Correction Narrative

Hackett Residence – 2965 74th Ave SE

COMMENT RESPONSES

SETBACKS

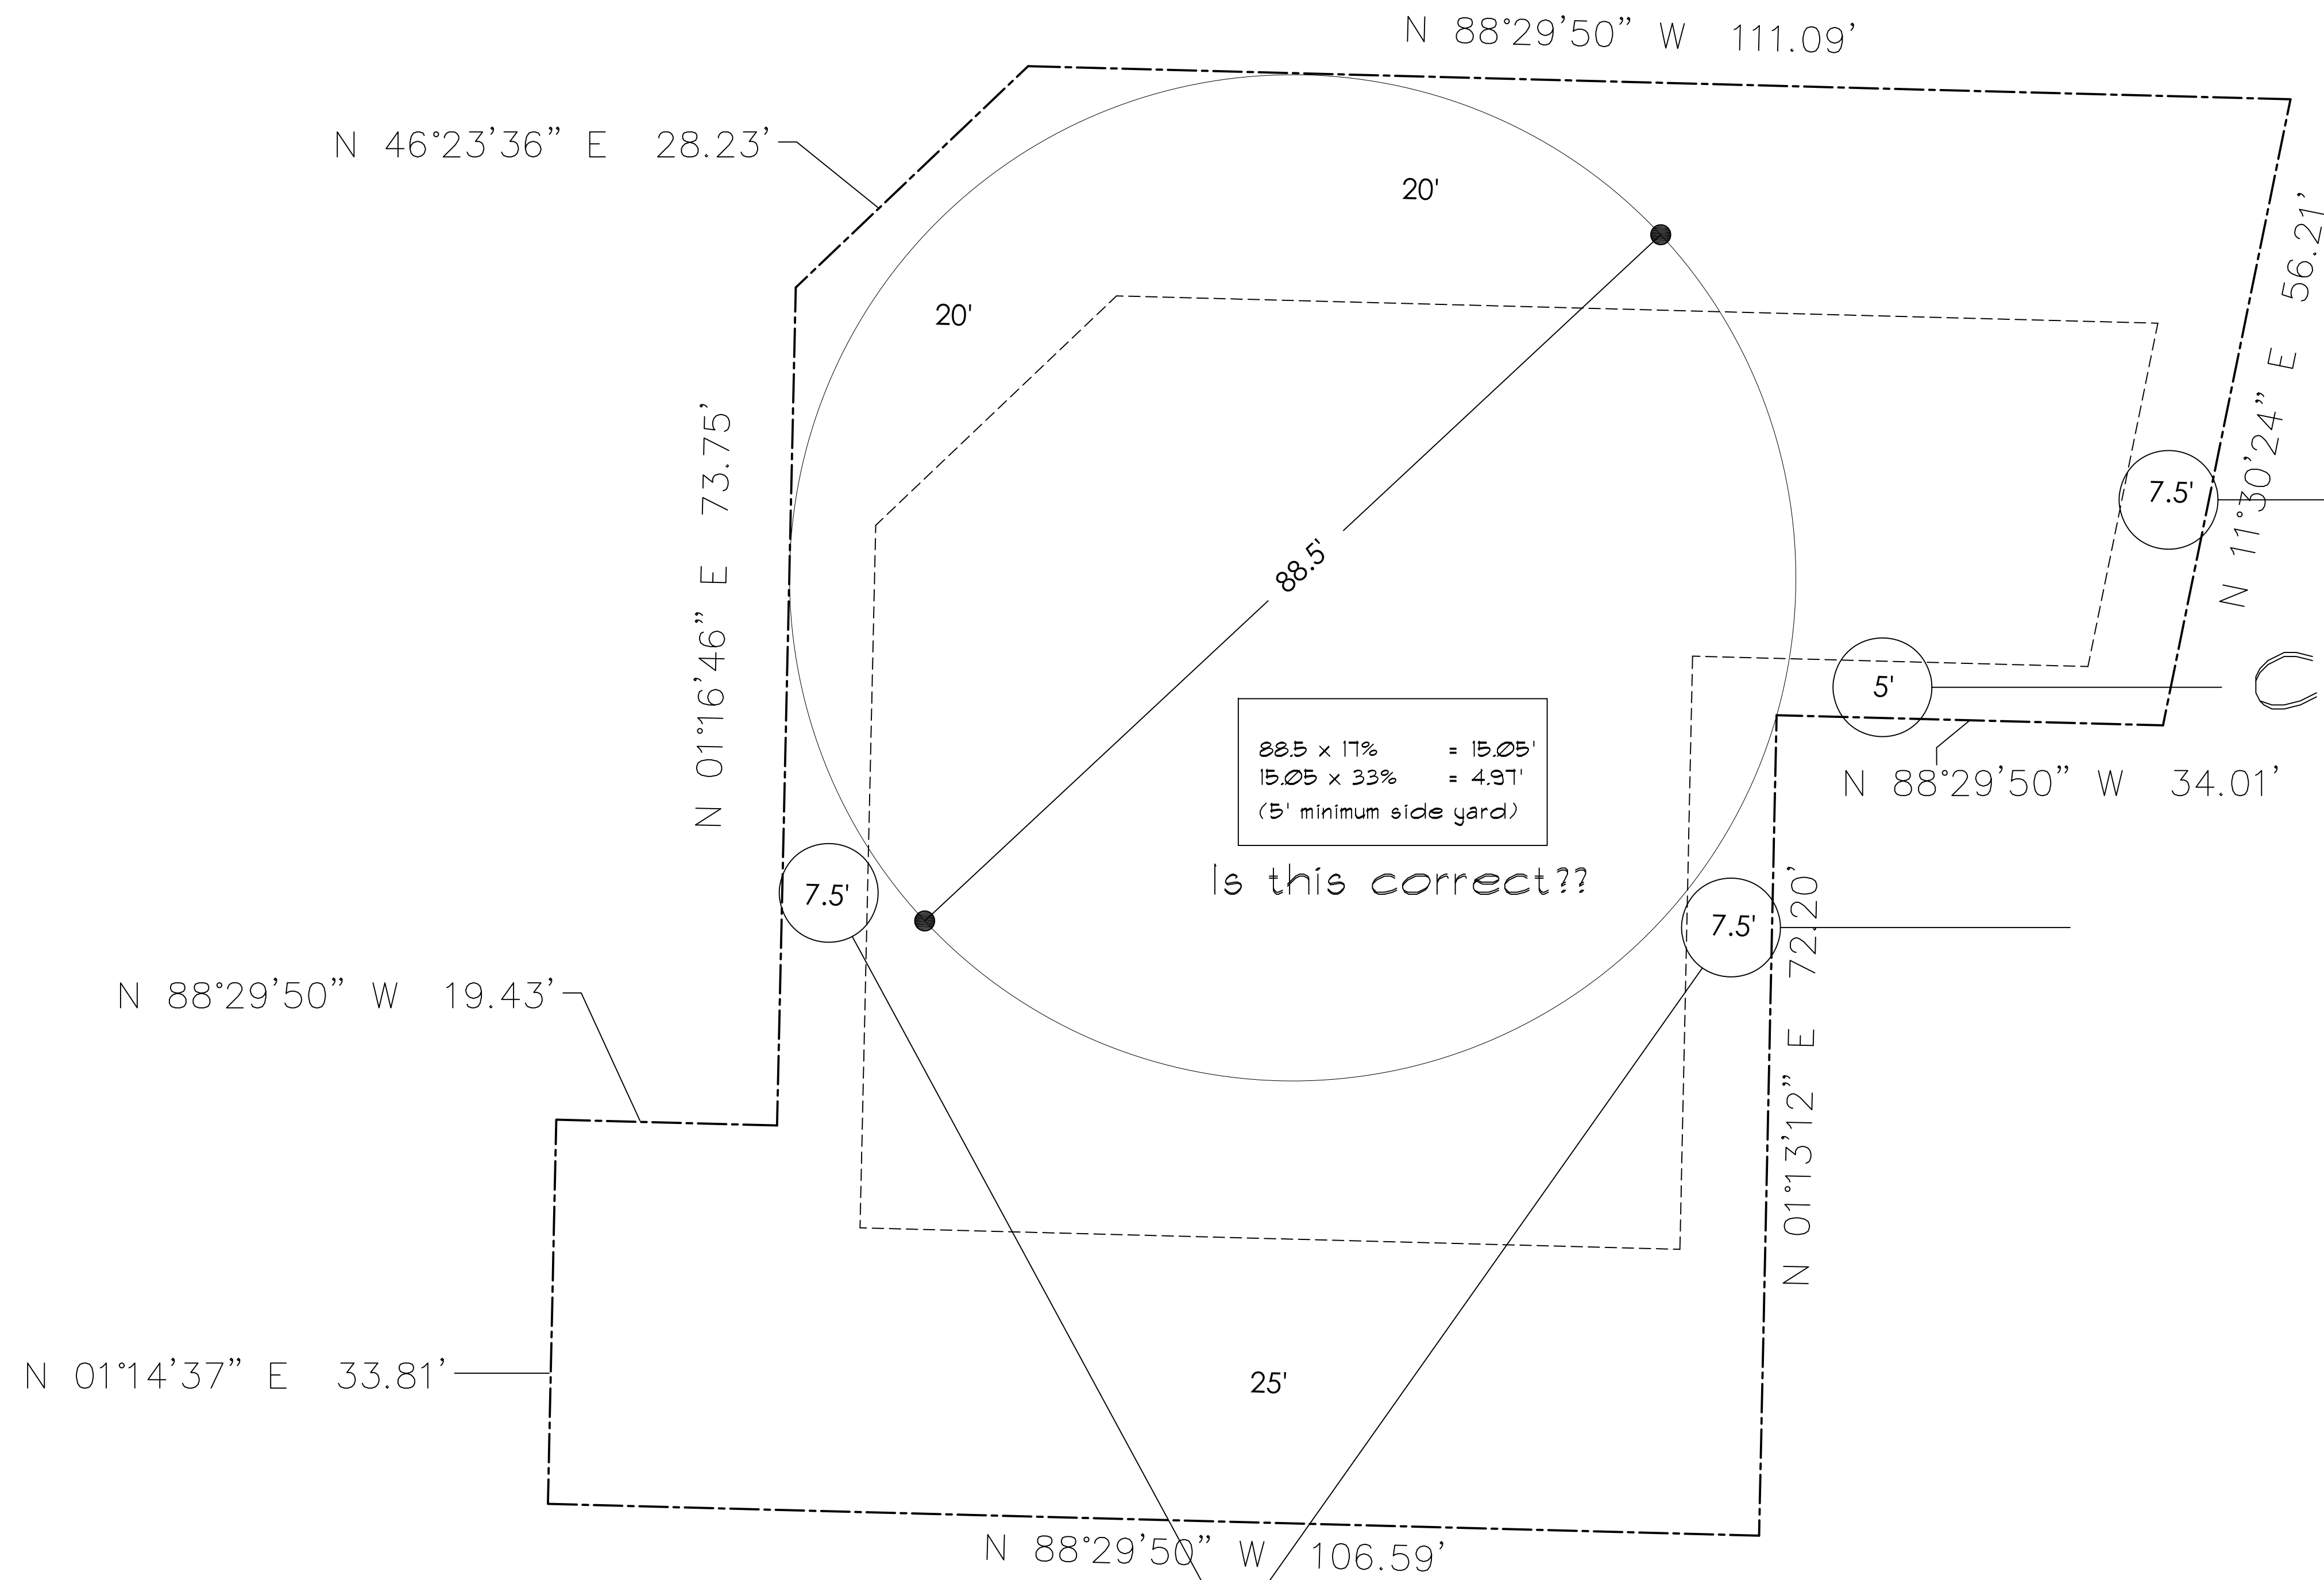
We have worked with our arborist to strategize for successful tree retention (please also see the new Tree Memo). In doing so, we've adjusted the building footprint to allow more distance between proposed building and tree #1. This was accomplished by moving the garage south on the property and reducing the size of the mud room.

Would this be 7.5 too?

Can I do this here?

Can I keep these at 7.5'?

Per email discussion with Grace Manahan (see following) we were advised on the correct setback determinations and have updated all setbacks appropriately.

That said, the first attached plan (not V2) looks like it may work, this is because depending on the new proposed height a 7.5' setback will most likely be required per MICC 19.02.020(C)(1)(c)(iii)(a).
